2011P025

# DRAINAGE REPORT FOR EAST BUCKEYE PARK AND RIDE BUCKEYE, ARIZONA

Project Name. East Buckeye Park & Ride

**FLOOD CONTROL DISTRICT MARICOPA COUNTY - 1st REVIEW COMMENTS**  
**Permit 2011P025 - EAST BUCKEYE PARK & RIDE – WHITE TANKS OUTFALL CHANNEL**  
May 26, 2011

Exhibit 1	11"x 17" Site Drainage Map
-----------	----------------------------

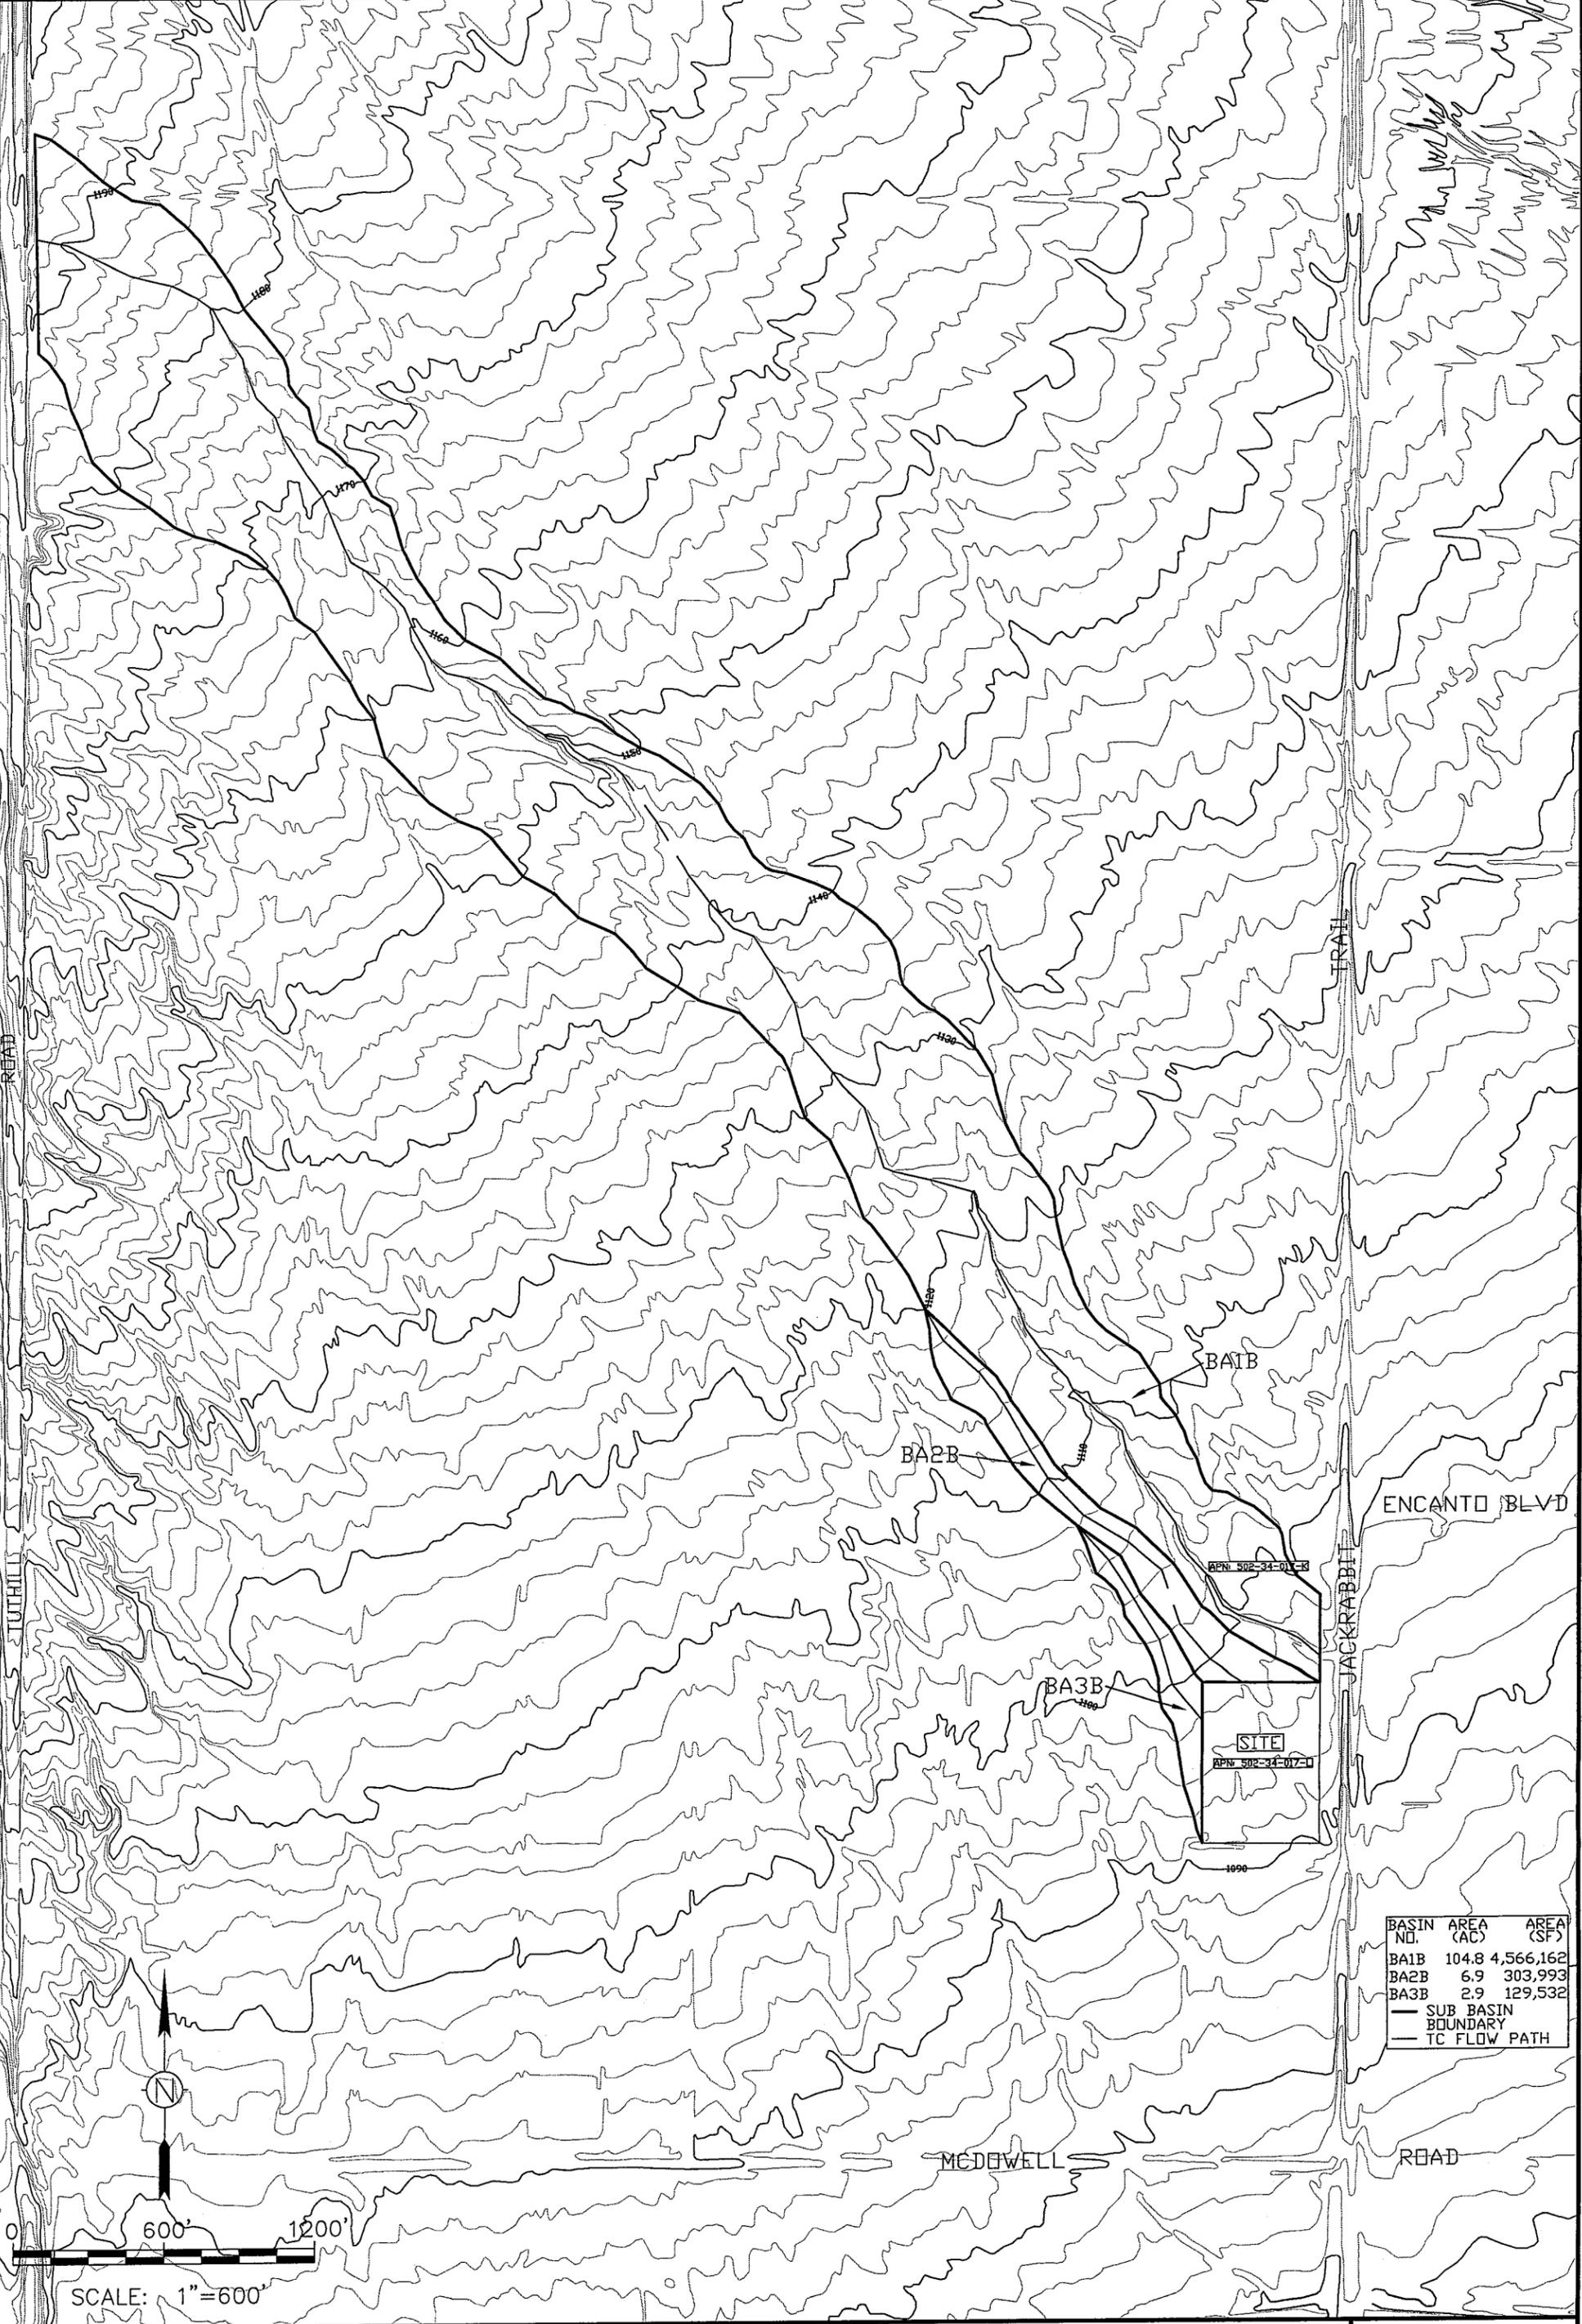
Appendix B shows retention requirements for DA-1 through DA-9; however, areas DA-1 through DA-5 are not shown on Exhibit 1 with DA-6 through DA-9. Exhibit 1 should be expanded to show all of the drainage areas related to the Park and Ride.

These are for On-site Drainage Areas and were not part of the flow entering the White Tanks FRS 3 Outfall Channel. Please refer to revised Drainage Report for On-Site Drainage.
